CONTAMINATION ASSESSMENT
PLAN ADDENDUM
HOWCO ENVIRONMENTAL
SERVICES, INC.
OGC CASE NO. 91-1176

RE: Contamination Assessment Plan (CAP) Addendum
Quality Assurance Project Plan (QAPP) Addendum
Howco Environmental Services, Inc., Pinellas County
OGC Case No. 91-1176 / FGS Project No. G92-308.04

The following information is provided as requested in your letter to Mr. Tim Hagen (HOWCO) dated December 4, 1992. Our responses correspond numerically to your comments.

FIGURE 1
HOWCO ENVIRONMENTAL
CURRENT CONFIGURATION

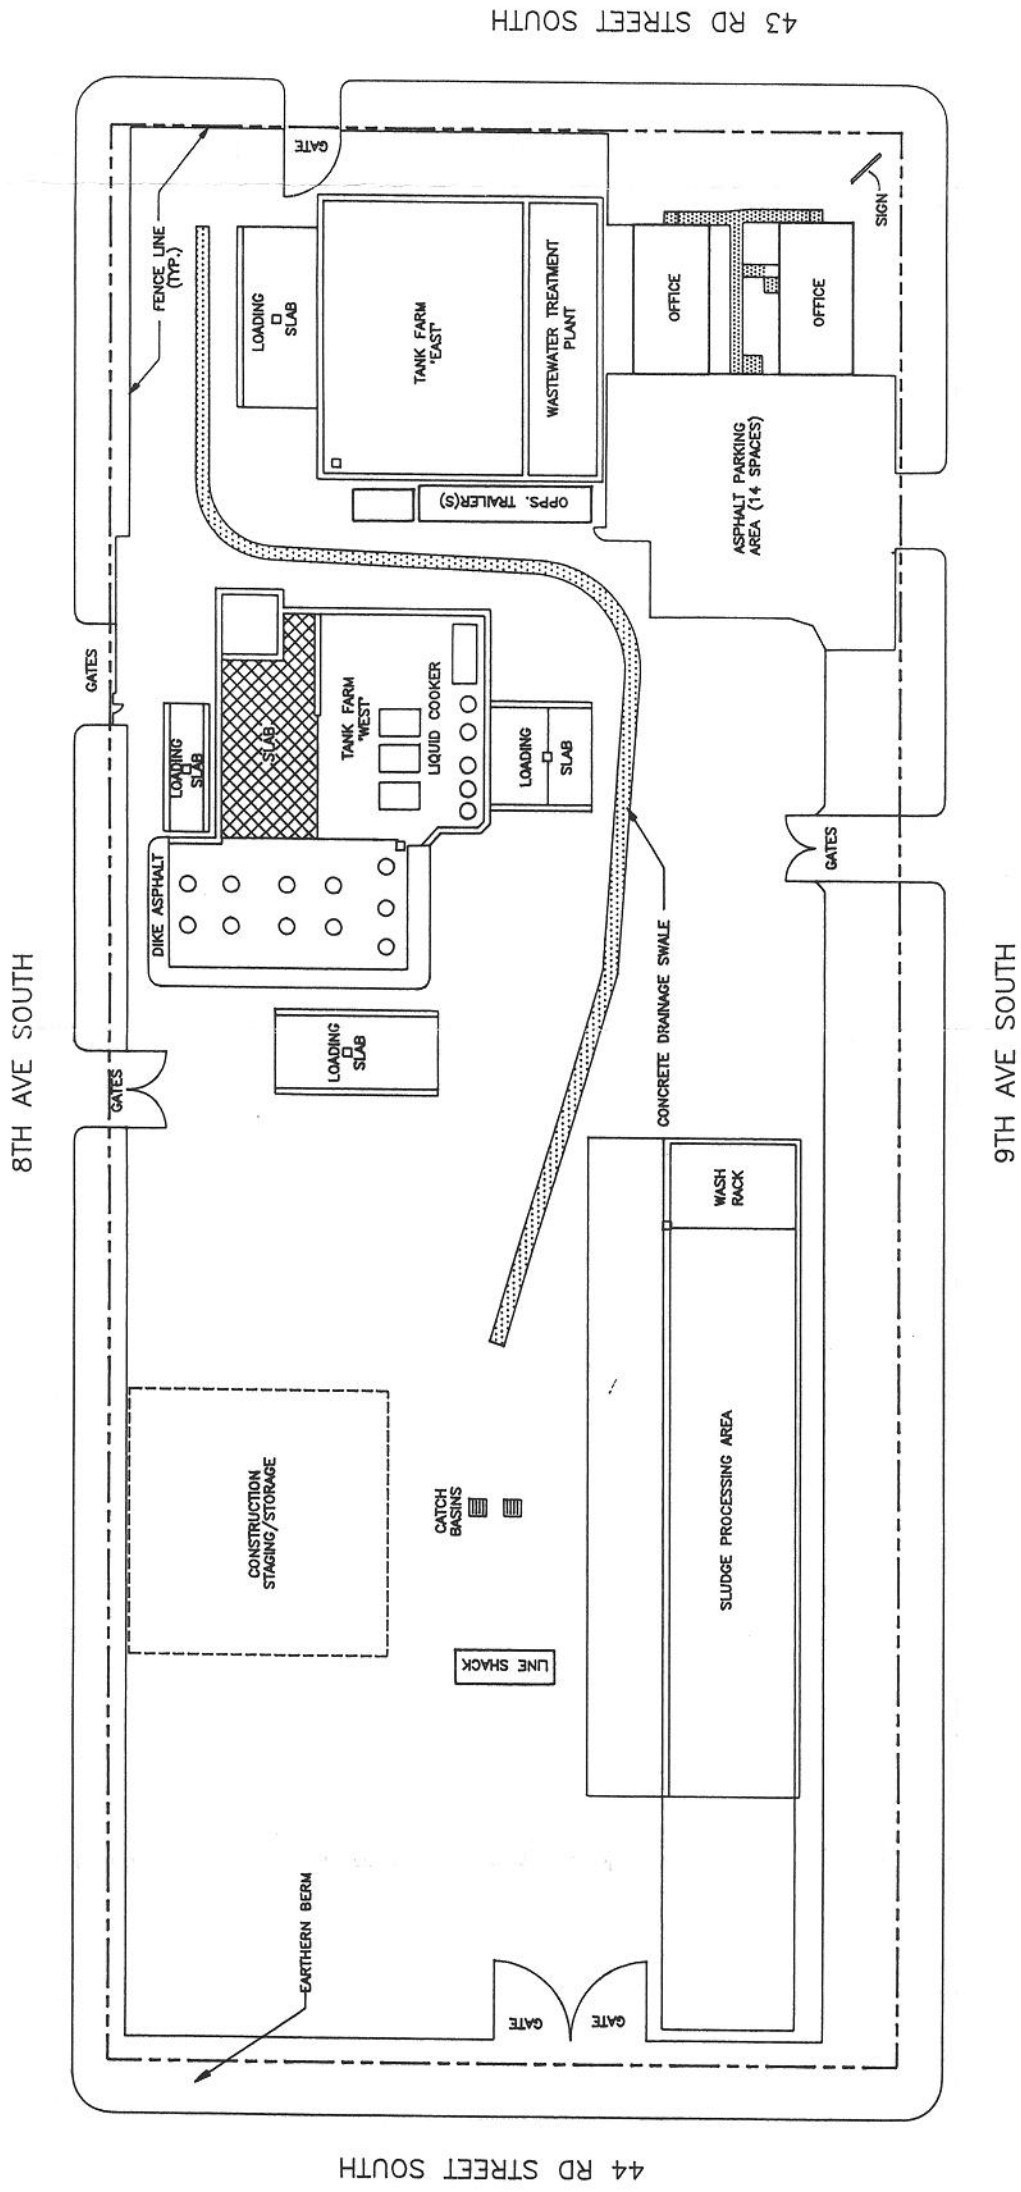
There are references in the CAP and PCAR to analytical procedures and cleanup criteria for the Kerosene and Mixed Product analytical groups in Chapter 17-770, FAC. No information has been provided to demonstrate that the contaminants of concern for this site are diesel, Jet-A, JP-5, kerosene, equivalent petroleum product, Jet-B, JP-4, or gasoline analytical product.

Table 1-1 of the PCAR summarizes the waste streams accepted by HOWCO. Since residual petroleum products accepted include waste fuels and oils from storage tanks at gasoline stations, airport fueling facilities, ship bilges, etc..., it is theoretically possible that any of the petroleum products mentioned in Comment 2 could be a contaminant of concern. Furthermore, HOWCO does not accept any petroleum products, including "used oil", that would be considered a hazardous waste because of mixing of the oil with hazardous waste as defined in 40 CFR Section 261, Subpart D. Therefore, the contaminants of concern are probably best characterized as being from the "Mixed Product" analytical group rather than the "Kerosene Analytical" group as both are defined in Chapter 17-770.200(7), FAC (Figure 1 shows locations of existing tank farms).

FIGURE 2
PIPING AND DRAINAGE DIAGRAM
HOWCO ENVIRONMENTAL

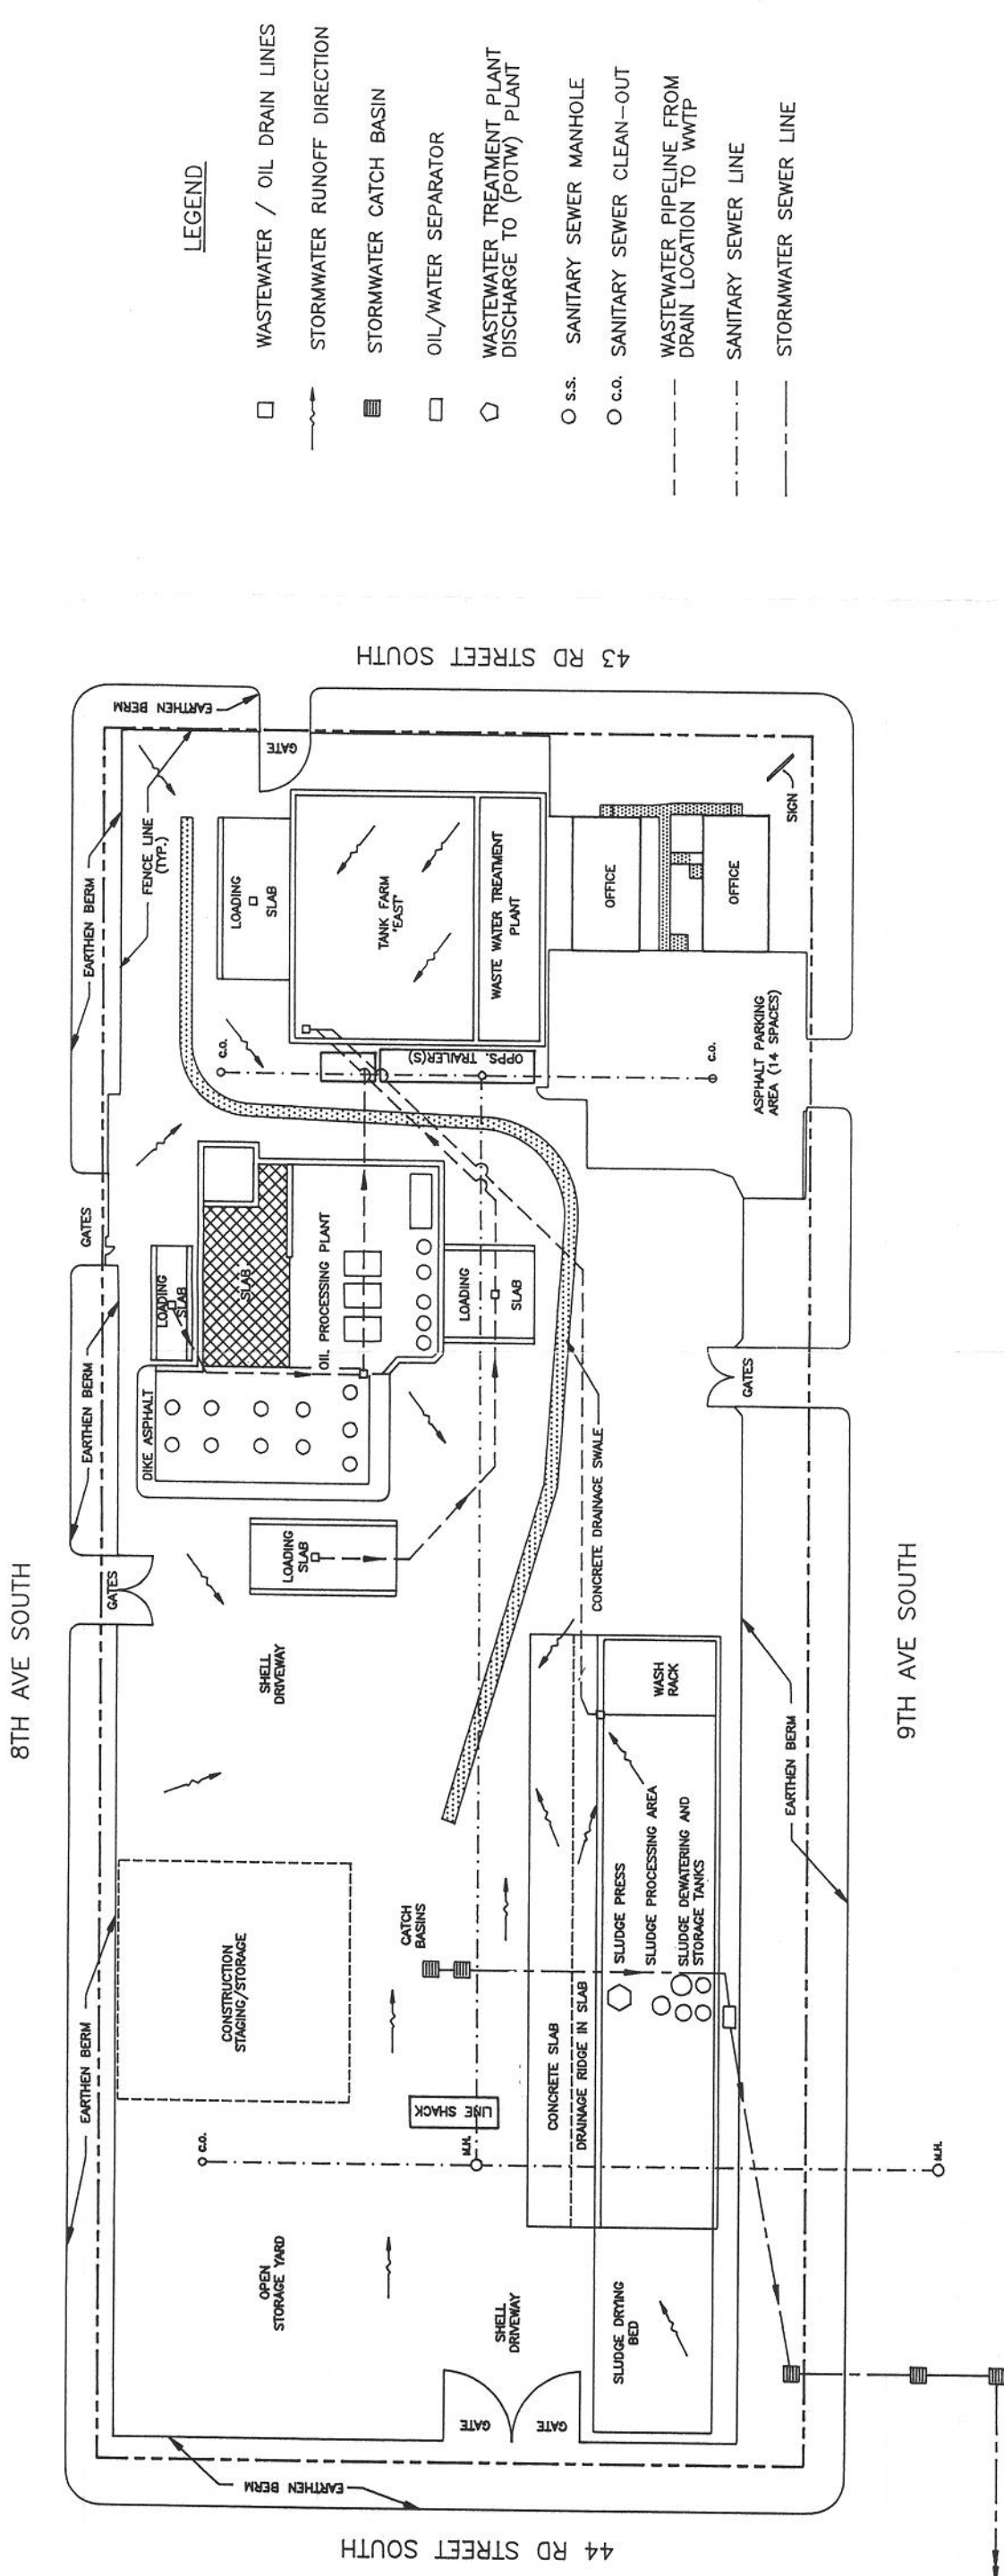
A detailed description of past and present site operations needs to be provided. In particular, there was no discussion of activities at the former and present wash rack area and Areas 2,3,4,5,6,7,8 and the southern half of Area 9. An asphalt production operation in the vicinity of the current wash rack area was mentioned but not investigated. The location of all pipelines for wastewater management, etc. should be identified on a site map.

More details on the existing stormwater management system should be provided. Is the stormwater collected before treatment in the wastewater treatment plant? The dimensions of the drainage swale should be provided. Has the drainage swale ever overflowed?

The old and new wash rack areas have always been used for cleaning road dirt and dust from trucks, rinse trailers and other company vehicles, the wash rack is concrete lined, bermed and has a collection sump for wastewater (Figure 2). All wastewater generated from the wash rack is recovered and treated at the on-site WWTP.

Figure 2 shows all drain locations for the collection of wastewater and piping routes to the WWTP.

Figure 2 also shows how stormwater is collected across the site. As shown, all stormwater is directed by gravity drainage to two centrally located catch basins. Also, an approximate five foot (5') wide concrete swale has been constructed to move stormwater more effectively from the eastern portion of the site. Stormwater collected in the loading slabs, containment areas, etc. was pumped to the WWTP and treated prior to discharge to the City of St. Petersburg sanitary sewer. Stormwater collected from non-contained areas is also pumped to the WWTP. However, during excessive rainfall events some stormwater is allowed to discharge to the storm sewer system at the outfall. The drainage swale and catch basins have both overflowed during heavy rainfall events.

Petroleum liquids are received at the Oil Processing Plant (see Figure 2). Specially designed cooker tanks remove excessive water from the fluids leaving behind a suitable "oil" that can be recycled for fuel or lubricating purposes. Sludges from oil/water separators are dewatered using a sludge press. Remaining solids are dried, blended and subsequently tested and incinerated at an off-site DER licensed thermal treatment facility. All wastewater generated during these recycling processes is treated (i.e. air stripping, charcoal, etc.), tested and discharged to the City of St. Petersburg Sanitary Sewer pursuant to permit #SPFL-5093-86-32.

FIGURE 3
PROPOSED SOIL BORINGS
ANS MONITORING WELL LOCATIONS

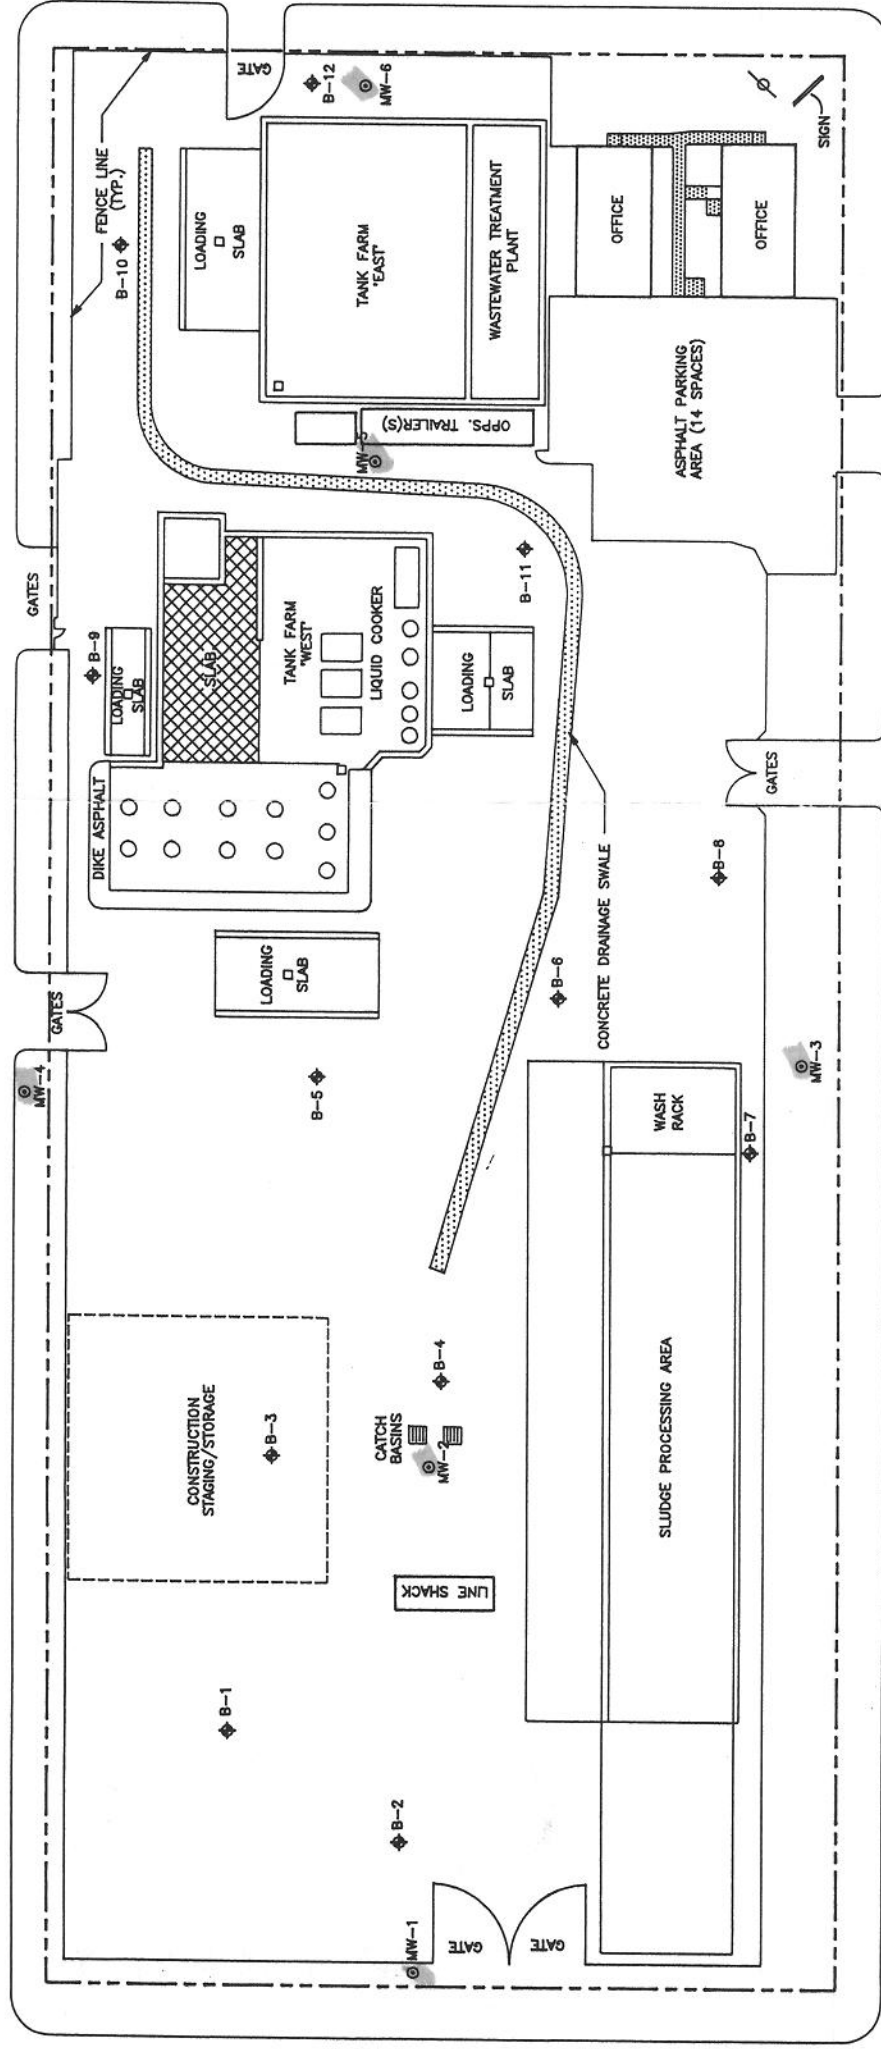
In Exhibit II of the Consent Order, the Summary of Violations includes the unpermitted discharge of petroleum contaminated stormwater to the groundwater and to the storm sewer system. These areas should be discussed, identified on a site map and investigated in the CAP.

The CAP needs to include the necessary investigations to identify, characterize and delineate the extent of all potential contaminant sources at the site. Analytical parameters may need to be expanded in response to comments 3 and 6 above.

Based on the data provided in the CAP and PCAR, additional soil investigations should be conducted, at a minimum, on the south side of the drainage swale, east of SB-6 and SB-5, and in the vicinity of TP-13 and TP-16.

Please provide the justification for the location of the proposed monitor wells. The location for the deep well was not identified on the site map. The intended purpose of this deep well is not clear. One deep well may not be adequate to delineate the extent of groundwater contamination.

Figure 3 shows the locations of suspect areas identified in Exhibit II of the Consent Order. As shown, groundwater samples will be collected from these areas and analyzed for the parameters specified in Section 2.2.2 of the CAP.

In order to further assess and characterize contaminated soil beneath the site, 12 additional soil borings will be installed at the locations shown on Figure 3. All borings will be conducted using the hollow-stem auger drilling technique. Information compiled from these borings will be evaluated and subsequently correlated with information obtained during the PCAR to more definitively characterize and delineate the extent of soil contamination. All tasks related to the hollow stem auger borings will be conducted in accordance with the following:

- 5) A background soil sample will be collected at a depth of five feet (5') BGS at the location shown on Figure 3 and analyzed for TRPH, and 8 RCRA metals.

Boring B-6 will test the area south of the drainage swale. Boring B-12 will test the area east of both ERM borings SB-6 and SB-5, boring B-2 will test previous test pit location TB_13 and finally B-5 will test previous test pit location TP-16 (see Figure 3).

Figure 3 shows the locations of water table groundwater monitoring wells to be installed to preliminarily determine the potential for groundwater contamination. The locations and number of wells recommended should be adequate to intercept any groundwater contaminant plume migrating away from the source areas identified in the PCAR. Also, the proposed well locations will test the groundwater in all of the areas where excess soil contamination has been documented (Areas 1, 2, 3, 4, 5 and 6). Furthermore, the preliminary monitoring well locations will be in a position suitable to detect any off-site movement of potential plumes.
